Memo

Subject Response to information request from DEHP
From Rohan Lucas
Distribution BMA
Date 12 February 2016
Project Broadmeadow EA amendment – Watercourse Subsidence

Figure 1 – Isaac River peak flow record at the Goonyella Gauge at downstream end of diversion

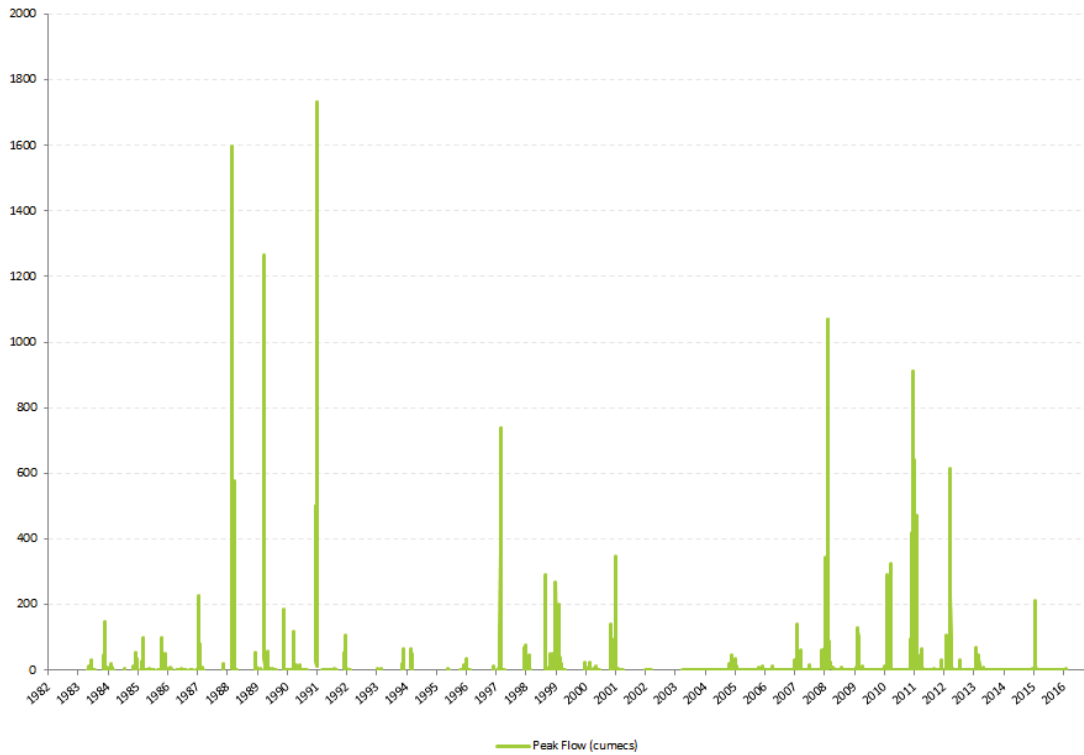
Based on observation (monitoring of the diversion and subsidence has been in place since 2007), it is flows in the order of 100-500m³/s that elevate this threat. Larger and sustained flows that infill the subsidence voids, have a short risk window until they mobilise enough sediment into the subsided sections from upstream to mitigate the threat from being ongoing.

50-yr ARI –Existing Conditions

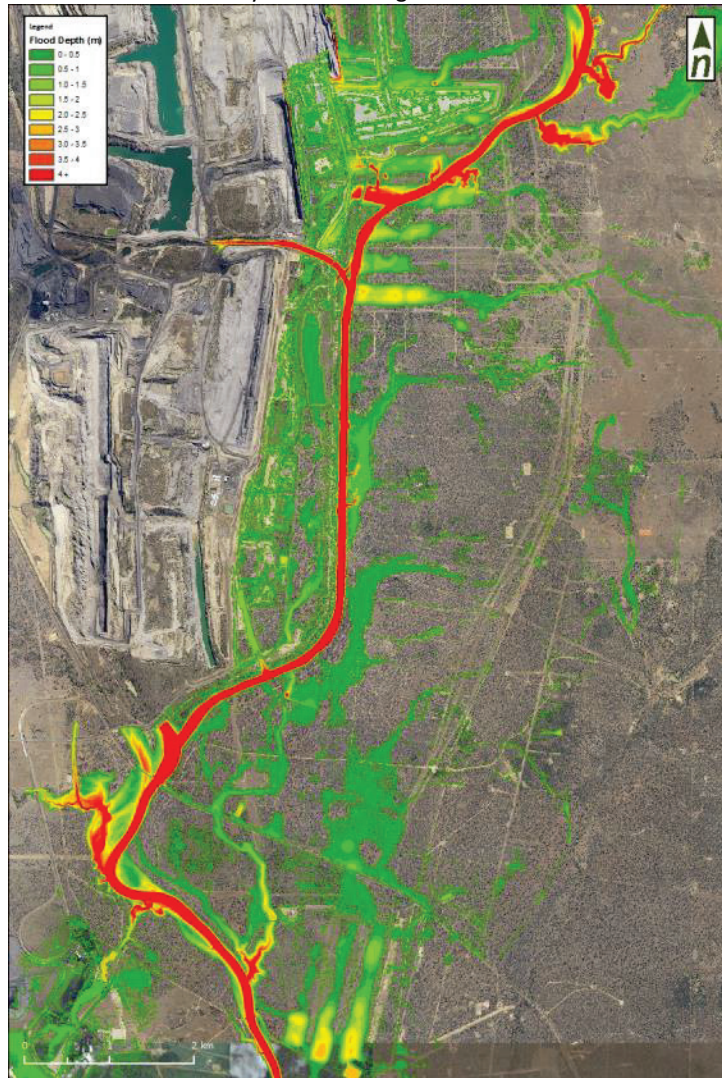
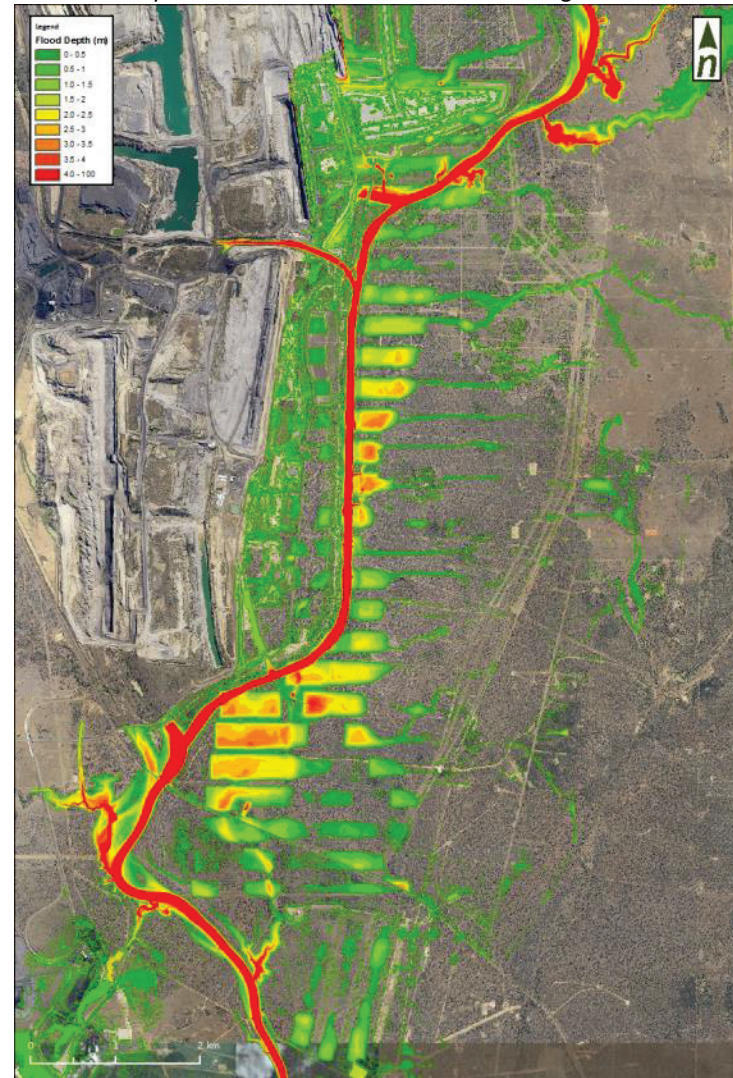
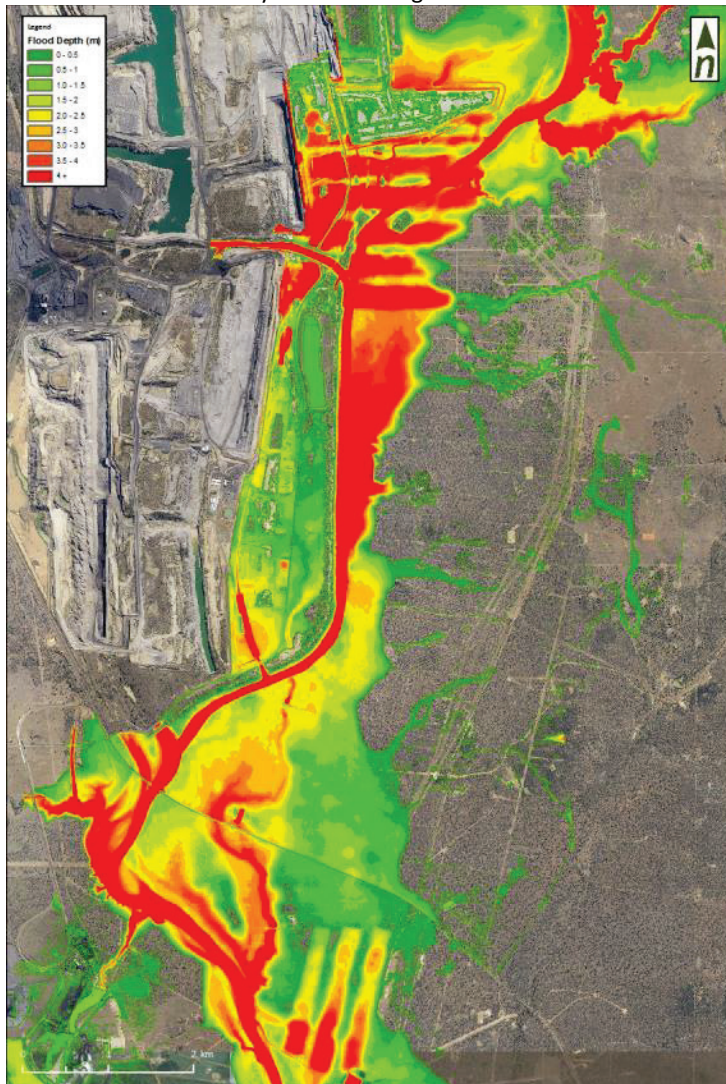
The administering authority requires clarification regarding the potential to re-orient some of the later panels in the Broadmeadow mine plan. These could potentially be altered from an orientation perpendicular to the Isaac River to parallel it, which could alter the potential for an avulsion of the Isaac River.

The magnitude of event to engage the floodplain will decrease slightly once all panels are subsided and the channel bed becomes infilled with sediment through the subsidence voids (the 1:50 and 1:1000 AEP events are provided below comparing 2015 conditions with full subsidence (no infilling) conditions). Where panels are perpendicular to flows, the pillar zones will form ridges between panels that will not provide for preferential concentration of flow. Should the panels be oriented parallel with flow, which has not been modelled for Broadmeadow, the potential for flood flow concentration increases. Hence the potential for avulsion increases if the materials are erodible. In the instance of the Isaac River terrace, the materials will be erodible.
